**SUNDRY NOTICES AND REPORTS ON WELLS**  
 Do not use this form for proposals to drill or to re-enter an abandoned well. Use form 3160-3 (APD) for such proposals.

CHEVRON RESPECTFULLY REQUEST THE ABILITY TO BATCH DRILL THE HH SO 8 P2. THE WELLS INCLUDED ARE

Changes to APD for Federal Wells

**PECOS DISTRICT  
CONDITIONS OF APPROVAL**

TA Cap, EBS-F-RH, 9"  
13-5/8" SM  
Part # 399984 - Rental

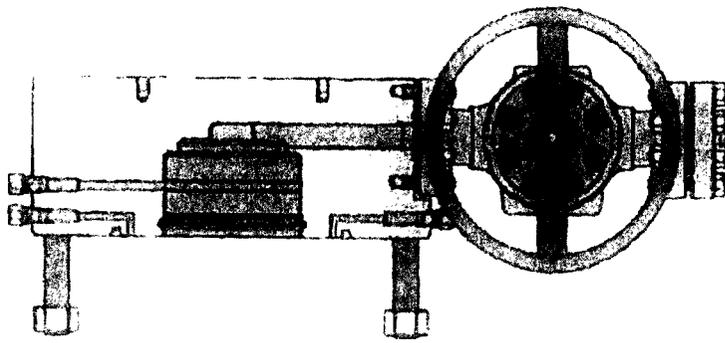
1. Drill 17-1/2" surface hole with fresh water to planned casing set depth with 10' rat hole.
2. Run casing as stated by approved APD, land out wellhead, and cement.
3. Dress out 13-5/8" 5M SH-2 wellhead and install/secure with temporary abandonment cap, and a pressure gauge will be installed. Reference image below *Part U 399984*
4. Skid to next well according to below "Drill Order"  
*Repeat 1 through 3 until all six surface holes are drilled, cased and cemented*

- a. In the event the operator has proposed to drill multiple wells utilizing a skid/walking rig. Operator shall secure the wellbore on the current well, after installing and testing the wellhead, by installing a blind flange of like pressure rating to the wellhead and a pressure gauge that can be monitored while drilling is performed on the other well(s).
